TDD Link Monitor State Diagram

D0.a Comment #408

IEEE P802.3dm Task Force

Jan 19-22, 2026

Figure 202–28—Link Monitor state diagram

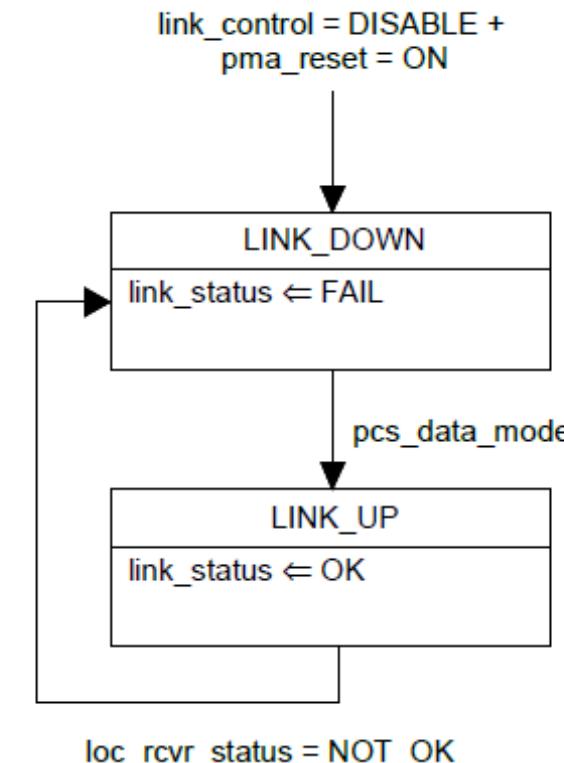
202.4.2.5 Link Monitor function

- Link Monitor determines the status of the underlying receive channel and communicates it via the variable link status.
- Failure of the underlying receive channel causes the PMA to set link status to FAIL, which in turn causes the PMA's clients to stop exchanging frames and restart the link.
- The Link Monitor function shall comply with the state diagram of Figure 202–28.

- A new variable “TDD_watchdog_status” is introduced in 202.4.4.1 and Figure 202–28.

- Update the bottom of Figure 202–28: $\text{loc_rcvr_status} = \text{NOT_OK} + \text{hi_rfer} + \text{TDD_watchdog_statyes} = \text{NOT_OK}$

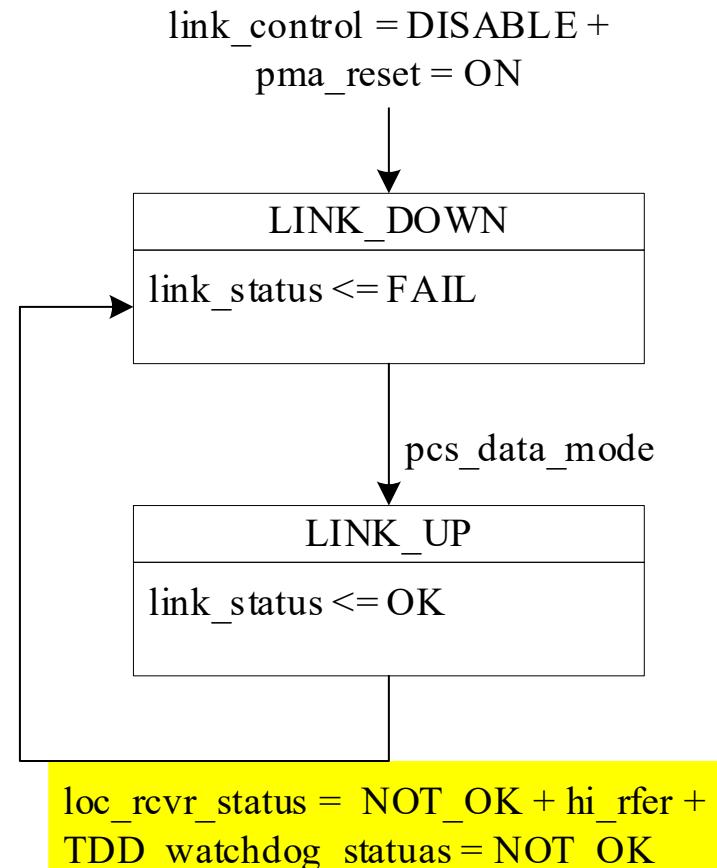
- For the variable “link_control” in 202.4.4.1, the definition in 96.4.7.1 is adopted:

link_control

This variable is generated by management or set by default..

Values: ENABLE or DISABLE.
